Staff Report to the Board of Architectural Review

File Number L13-0044 Design Review

Request Design Review approval for **Tukwila Village Project Phase 2** (See Sheet P1.1 of Attachment A)

Looking south along TIB at Coast Redwood

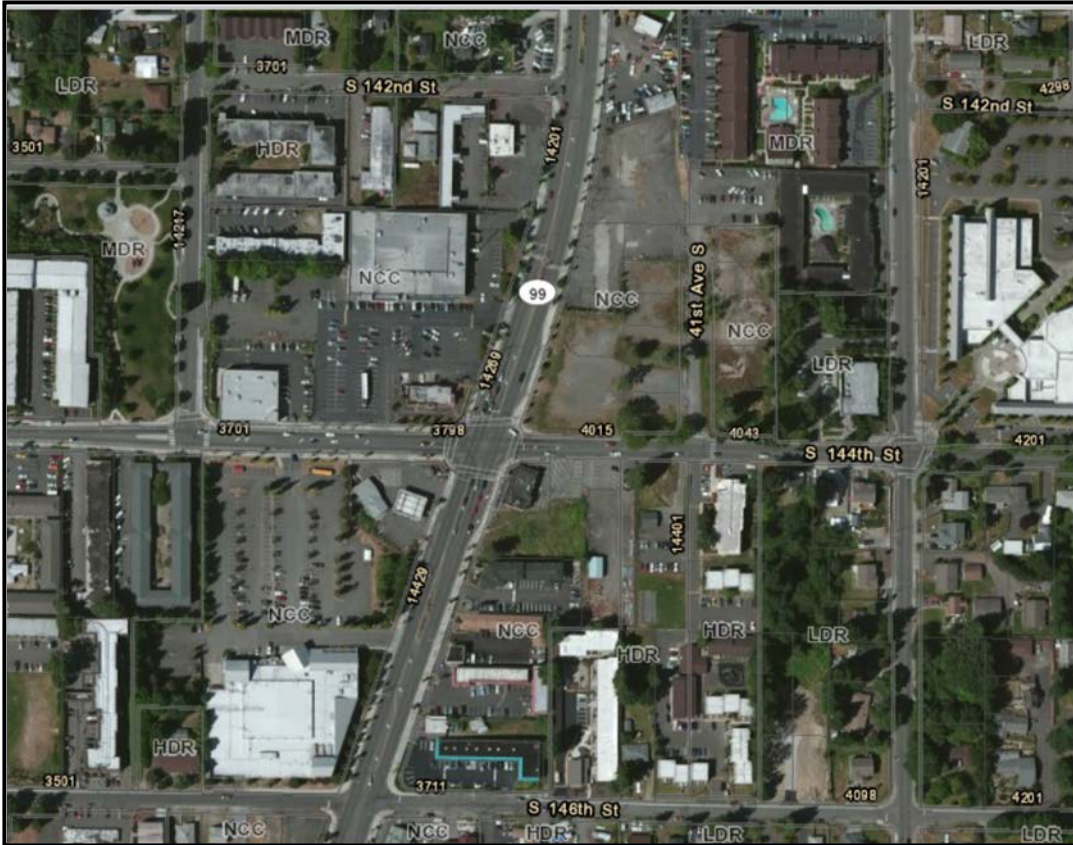
Where possible, canopy trees are used. In order to comply with policies of achieving greater canopy coverage and retain mature landscape, the Coast Redwood that is planned to be preserved, should be incorporated into the landscape plan to ensure that the future plants will be compatible with the tree.

6. In order to meet the criterion for Focal Areas in the Disposition and Development Agreement, the mature Coast Redwood tree should be lit at night.
 7. In order to meet Comprehensive Plan Policy 8.2.9 for creating a major pedestrian corridor, include seating along S 144th Street, for example outside the residential lobbies to enhance the pedestrian orientation of the corridor.
